Re: Dandridge Prop.

HOWARD COUNTY HEALTH DEPARTMENT

Review of 8/14/81 for
4 hot plat.

SEGAL PROPERTY

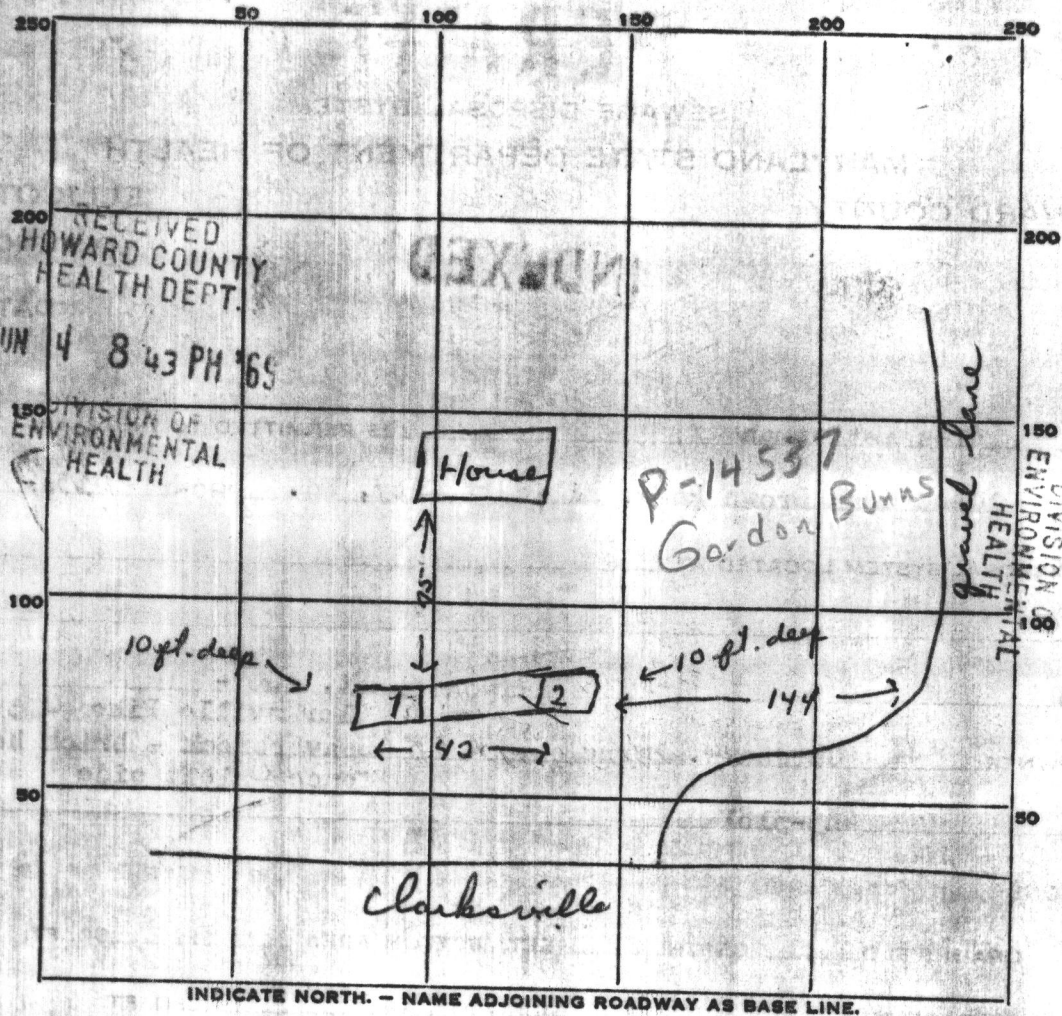
Recommend #1 Lot - Not show any house site, water well site, +/or sewage easement area until wet season check of property. 8/17/81 F.S. agrees - only can show hole if desire.

Recommend #2 Lot - Not approved until water line disconnected from existing well of existing house on #3 to barn on #2 LOT. yes per F.D.

Existing well, house + septic system S.R. OK. hole satisfactory

Recommend well site be moved to to Sept near corner of lot (over 8/17/81 as shown P.M. per F.D.)

Note: No building permit to be issued on Lot #2 until water supply for barn - disconnected from lot #3's existing water supply.

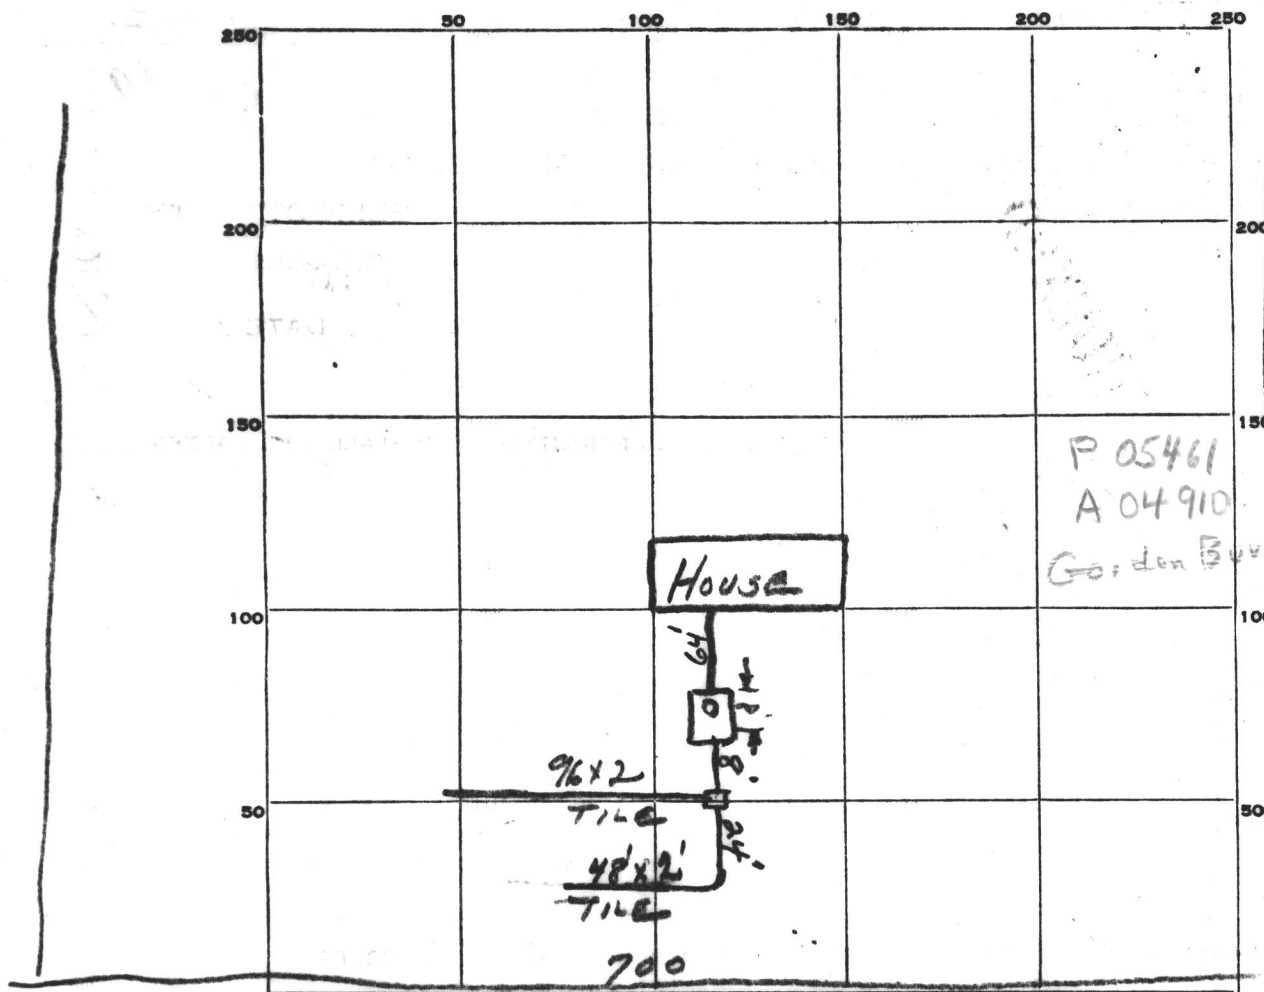
8-3-62
 REMARKS Need untreated paper over open jointed tiles
" untreated resin paper over trenches
" distribution box on far end trench nearest
road at bend in trench JH.

PROPERTY OF CARL A. SEGAL
5TH ELECTION DISTRICT HOWARD COUNTY MARYLAND
SCALE: 1" = 50' MAY 12, 1981

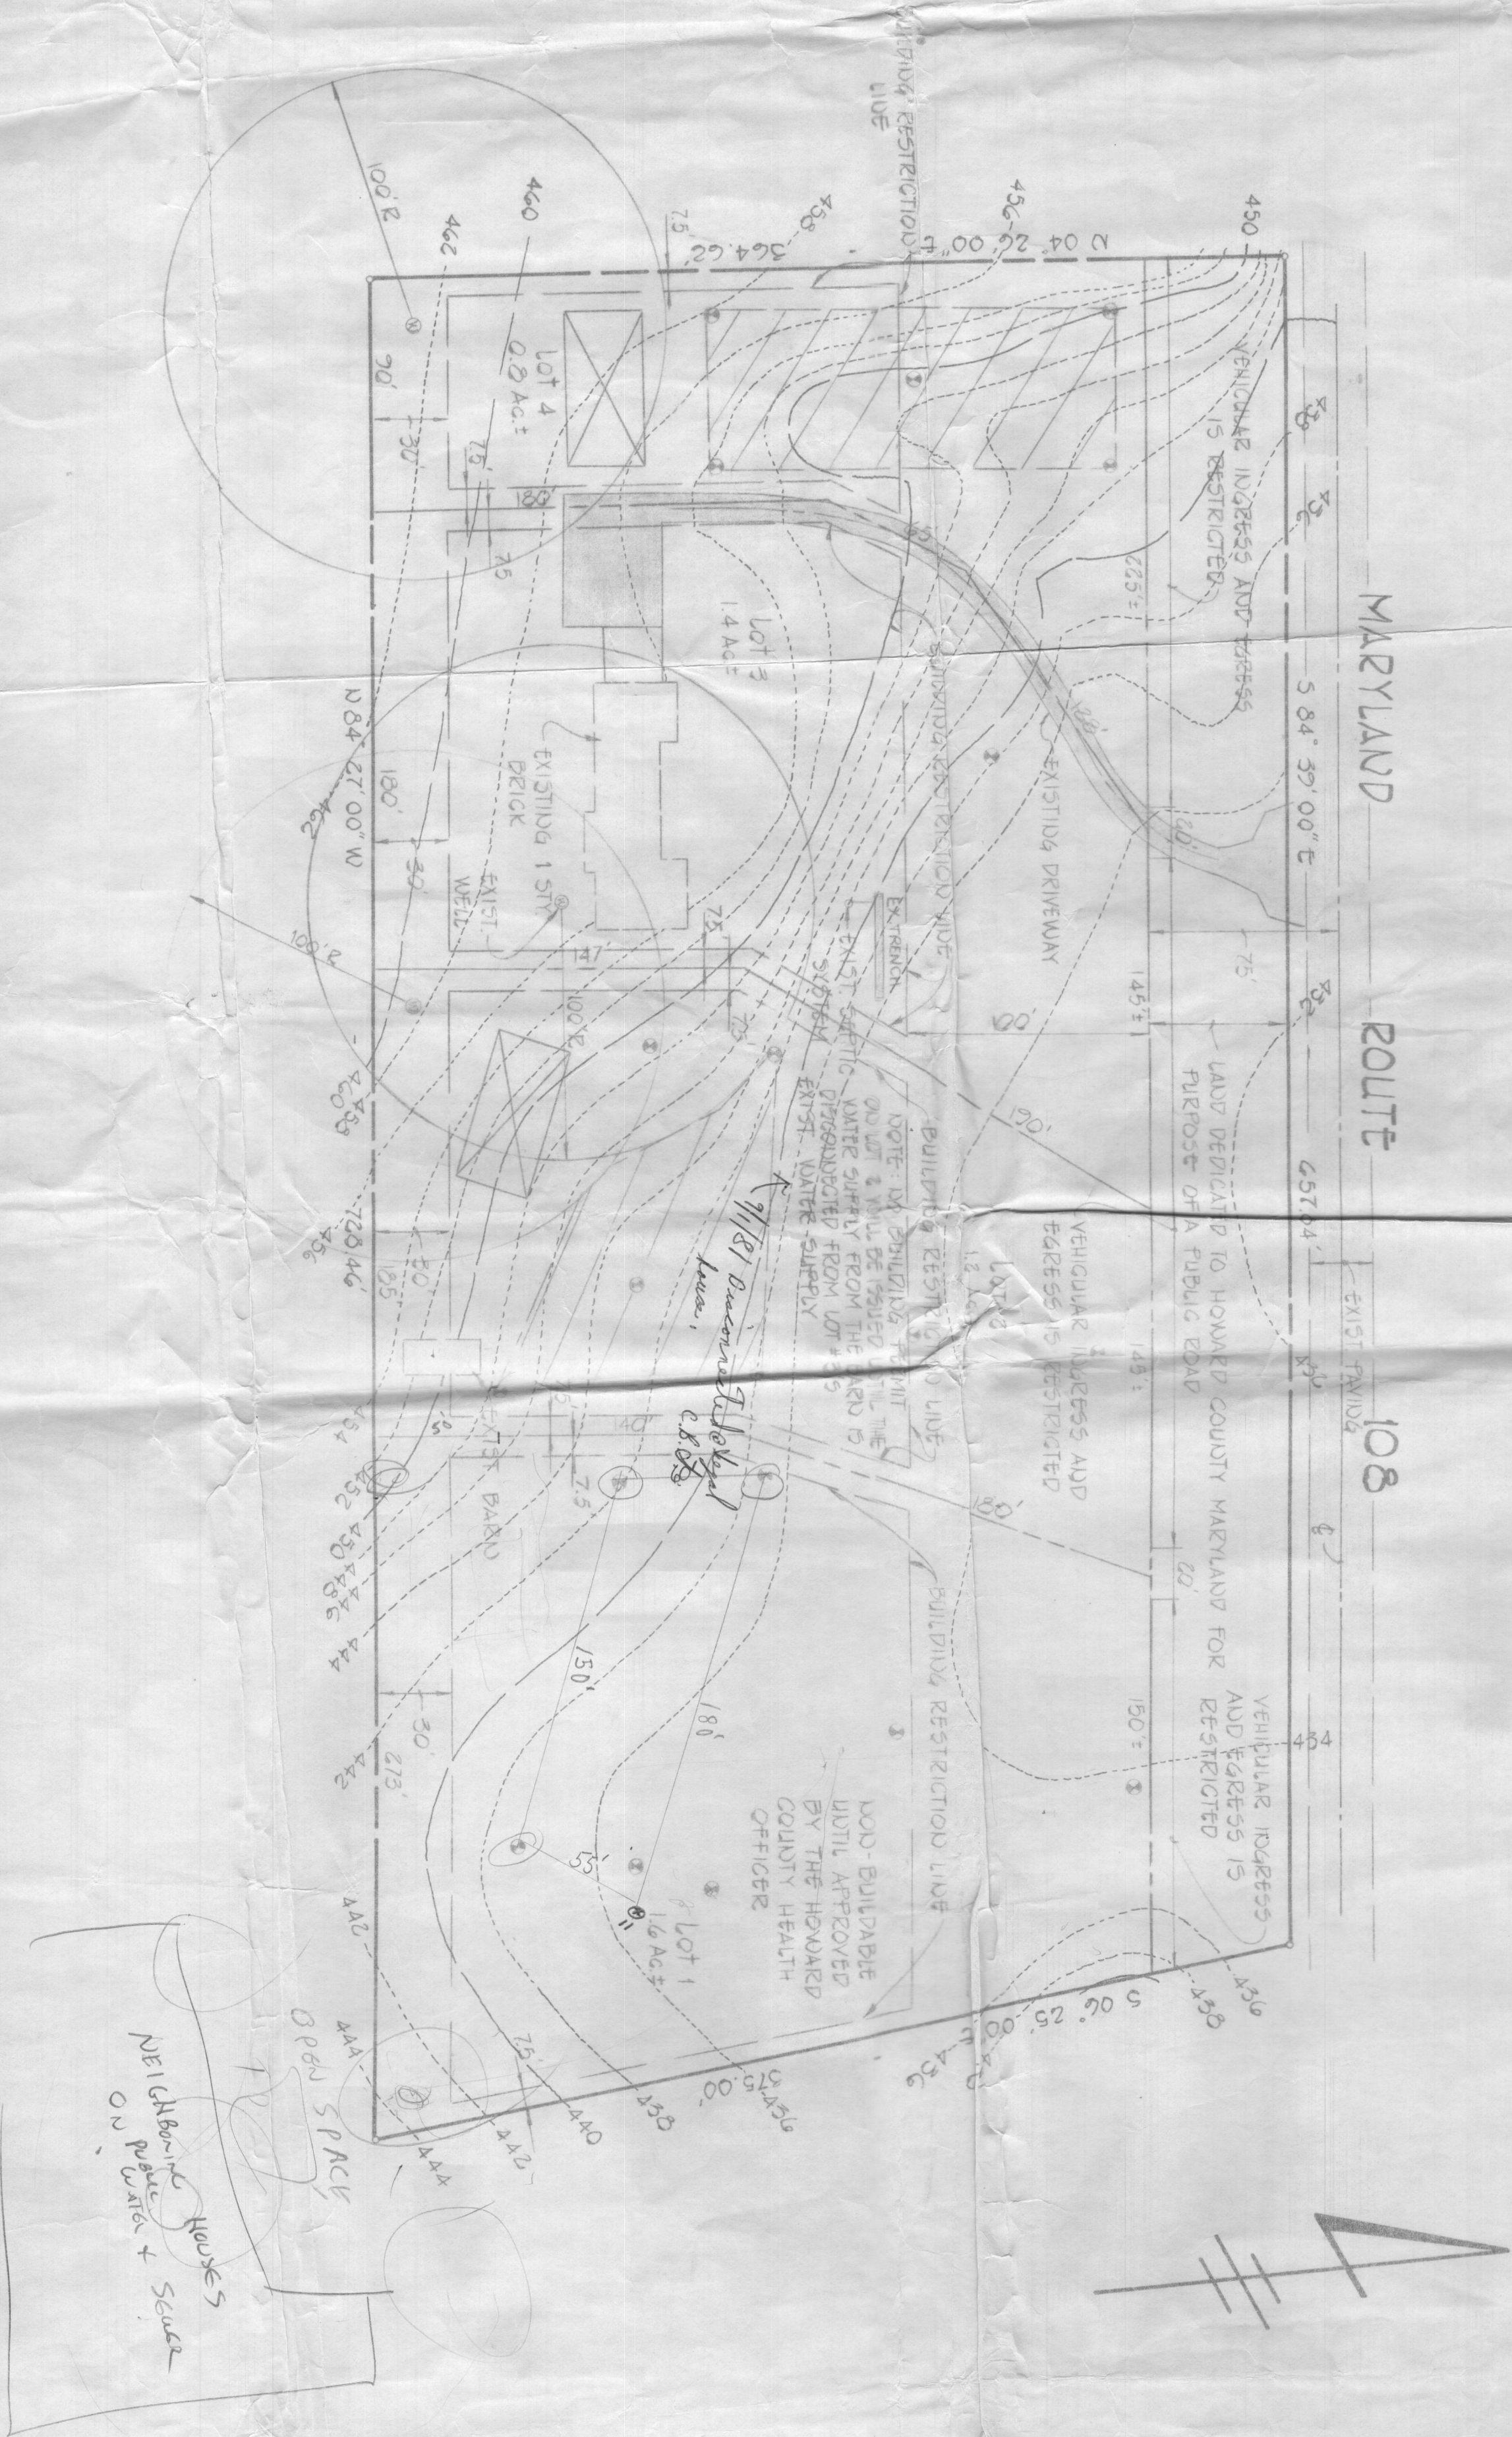
- septic system presently located at lower side of property - no repair area

- well not shown

- lot 5's sewage easement area is about where existing lot 4 S " " " should be.

8/19/81 Plot review - revised
plot satisfactory C.B.S.
~~(check with S.K.)~~
